Acoustic Report

33no. Social Housing Units in Kill, Co Kildare

Report for: Kildare County Council

Issue Date	Revision	Status
30 th August 2021	DRAFT	Suitable for review and comment

Figure 3-1 – Typical party wall base detail with typical ground bearing slab

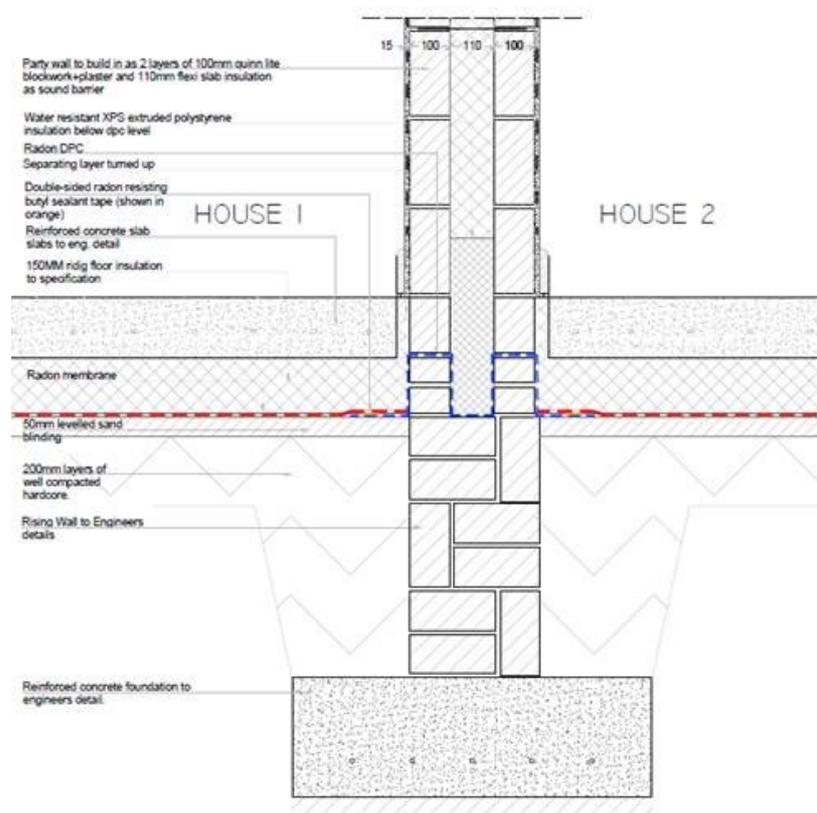
We note that a 'Quinn lite' aerated block is called up on the drawing. Aerated block are not suitable for this application, dense aggregate concrete block of block density 1900 kg/m³ (minimum). *Note: Figure 3-1 as currently shown is to be replaced by updated details showing a dense aggregate concrete block.*

1. Provide dense aggregate concrete blocks of at least 1900 kg/m³ density.
2. Provide a 13mm plaster/cement sand rende with plaster skim on both sides.
3. Lay the blocks in 225mm single course stretcher bond.
4. Fill all joints with mortar and fully seal the wall with all parts of the construction.
5. Connect the leaves of a masonry cavity wall only where necessary by butterfly ties. Alternatively, use wall ties with an appropriate measured dynamic stiffness for the cavity width < 4.8MN/m³.
6. There is to be no rigid connection between the two leaves excepted for wall ties and foundation. The cavity and wall ties must be kept free from mortar droppings and debris.

Figure 3-6 – Outline sketch of the floor buildup

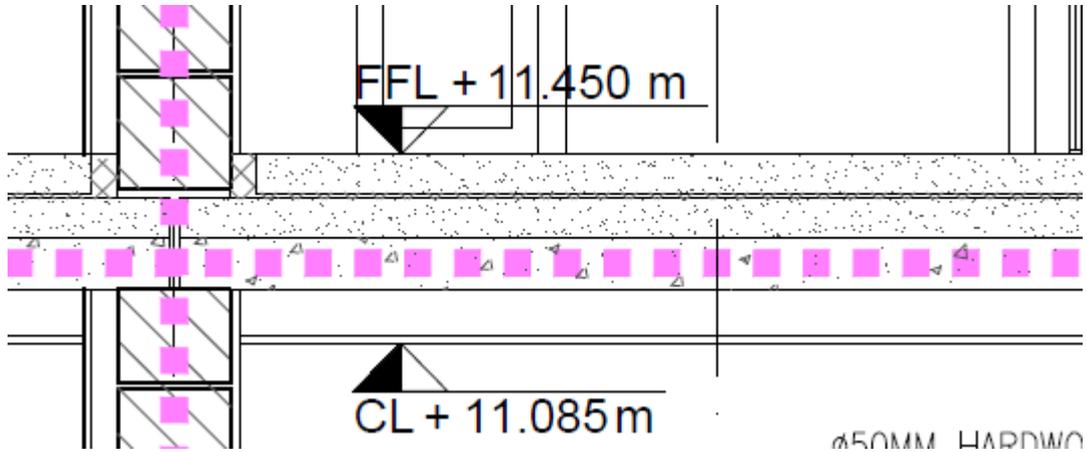
The proposed separating floor buildup does not conform to any of the *Approved Floor Types* from TGD, Part-E. Therefore, we have undertaken desktop modelling to estimate the airborne and impact sound insulation performance of the proposed buildup. For modelling purposes, we used data for a 15mm Gyproc Soundbloc board. We have also included a 25mm fibreglass/mineral wool quilt in the services void.

In summary, compliance with the minimum airborne and impact performance standards of Regulation E-1 have been demonstrated for the proposed floor buildup. Appendix A presents detailed calculation sheets for further information. We recommend the use of a 15mm Gyproc Soundbloc board and a 25mm fibreglass/mineral wool quilt in the services void.
